<b>SERVICE</b> 		<b>7</b> X 88.010-26
---	--	-------------------------

## RIDER 850 - model 1987

### SUPPORT BRACKET

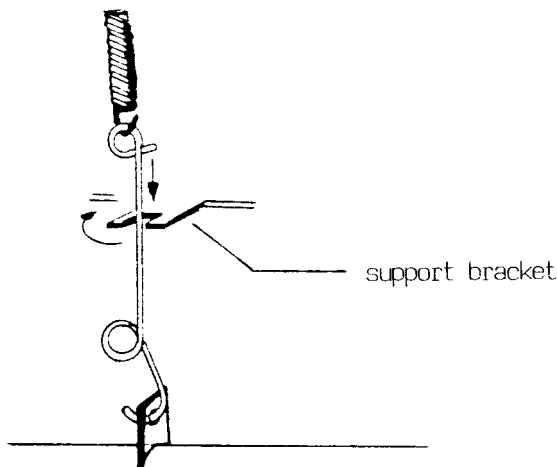
A for many well-known phenomenon which can happen on broken grounds is that the cutting unit can fall down too low. This occurs if you pass a rise in the lawn or a top and if the support wire (A) does not run in its groove on the bracket. Then when the unit touches flat ground again, the cutting unit will be pushed upwards. The bumper may then press the fender covers up so they break.

On the 1988 models, the support bracket and wire are replaced by rigid steel supports which are welded on the lifting frame. These supports can also be welded on to the 1987 model.

Put the front wheels on 30 mm high blocks and let the support rollers of the cutting unit rest against the floor. It should now be 10-15 mm play between the loop on the wire and the old bracket. This extra play secures a better function of the new support brackets. Fit the new supports according to the illustration. Remove them again and grind off the paint on the lifting frame where they are supposed to be welded. Again fit them and weld. Then remove the old support bracket Ref. No. 506 54 71-01, but let the spring and wire remain as before.
